Product / Process Change Notification (PCN)

PCN Number: PCN_IndHCI_20250206 Affected Series: WE-HCI Affected Part Numbers: See table below. PCN Date: 2024-11-06 (YYYY-MM-DD) Effective Date: 2025-02-06 (YYYY-MM-DD)	Change Category: ☐ Equipment/Location ☒ General Data ☐ Material ☐ Process ☐ Product Design ☐ Shipping/Packaging ☒ Supplier ☐ Software
Contact: Product Management Phone: +49 (0) 7942 - 945 5001 Fax: +49 (0) 7942 - 945 5179 E-Mail: pcn.eisos@we-online.com	Datasheet Change: ☒ Yes ☐ No Attachment: ☐ Yes ☒ No

Sizes: 5040

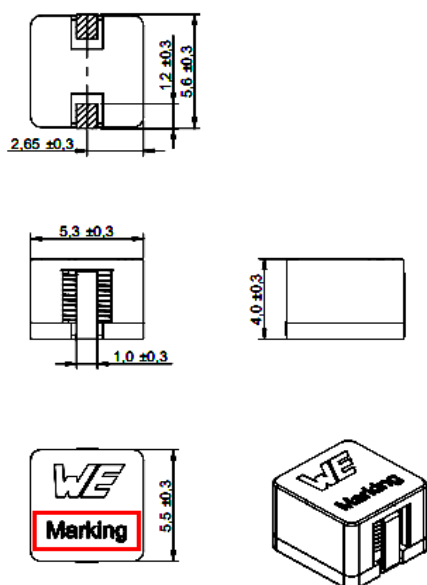
Because of database mismatch, Würth Elektronik eiSos will update the drawing and the description of the marking of the components in the datasheet for the part numbers indicated in table 1.

The datasheet drawing and the product marking description will change as shown below:
